REF: DRAINAGE REPORT FOR THOMAS VILLAGE ESTATES PHASE IV (G12-D11)

DRAINAGE REPORT
FOR
THOMAS VILLAGE ESTATES PHASE IV

REVISION TO
DRAINAGE REPORT (G12-D11) FOR
THOMAS VILLAGE ESTATES PHASE IV
JUNE 1987

TYPICAL SECTION

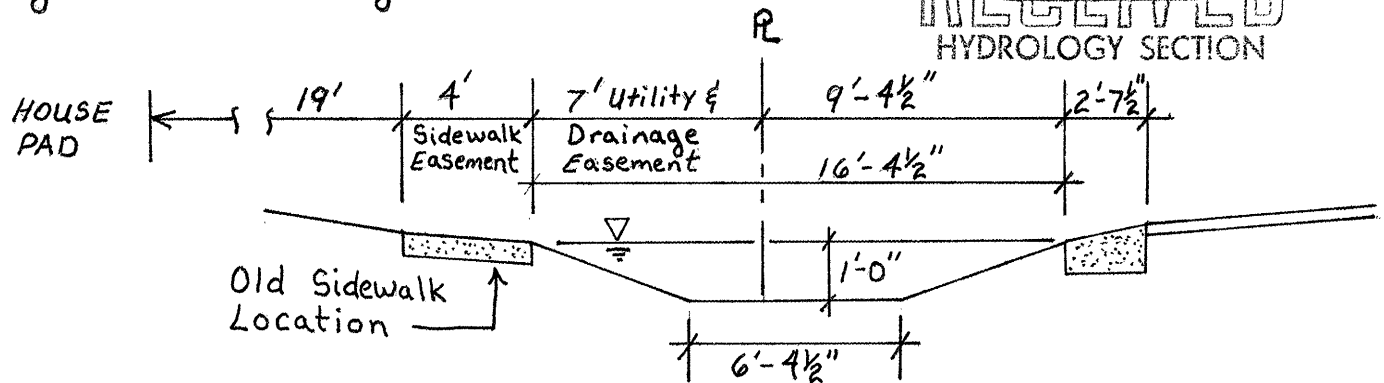
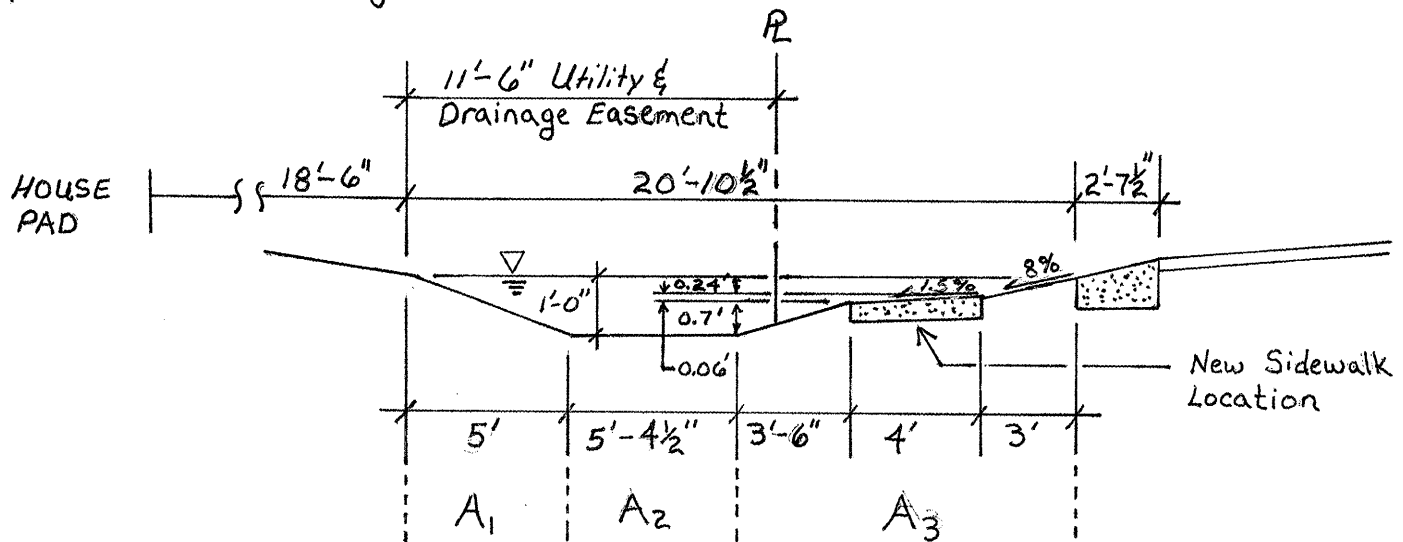
The proposed drainage revisions are shown on the grading plan included with this report. The original plan has only been revised to relocate the sidewalks. By relocating the sidewalks, ponding volumes in the front yards are affected, therefore, the major concern is in maintaining adequate front yard ponding volumes.

As shown in the proposed drainage plan, the lengths of the front yard ponds have either been maintained or extended, therefore, only a comparison of the cross sectional areas between the original pond design versus the proposed design needs to be addressed to assure adequate pond volume.

As shown by the calculations, the cross sectional area of the original pond design is 11.4 sq. ft. In the proposed design, the sidewalk has been relocated and the sidewalk easement vacated. The drainage and utility easement has been extended to 11.5 feet in width. The cross sectional area of the proposed design is 11.6 sq. ft., which is sufficient to maintain the previous pond volume.

1. Relocate the sidewalk 3 feet behind the back of curb.
2. Vacate the existing sidewalk easement.
3. Expand the drainage and utility easement to 11 1/2 feet to maintain the ponding volume.
4. Construct front lot ponds accordingly:
 - a. Combining public and private runoff within the street right-of-way and new 11 1/2 foot drainage easement.
 - b. A minimum distance of 15 feet from the house pad.
 - c. A maximum depth of 12 inches.
 - d. Using 5:1 side slopes.
 - e. Retaining the runoff from a 100-year frequency, 6-hour duration storm.

A = cross sectional area of the pond in square feet.
 $A = \frac{1}{2}(1)(16.375 + 6.375)$
 $= \underline{11.4 \text{ sf}}$

$A_1 = \frac{1}{2}(1)5 = 2.5 \text{ sf}$
 $A_2 = (1)5.375 = 5.375 \text{ sf}$
 $A_3 = \frac{1}{2}(0.7)3.5 + \frac{1}{2}(0.06)4 + 0.06(3.5) + \frac{1}{2}(0.24)3 + 0.24(7.5) = 3.715 \text{ sf}$

$\text{New } A = A_1 + A_2 + A_3$
 $= 2.5 + 5.375 + 3.715 = \underline{11.6 \text{ sf}} > 11.4 \text{ sf}$
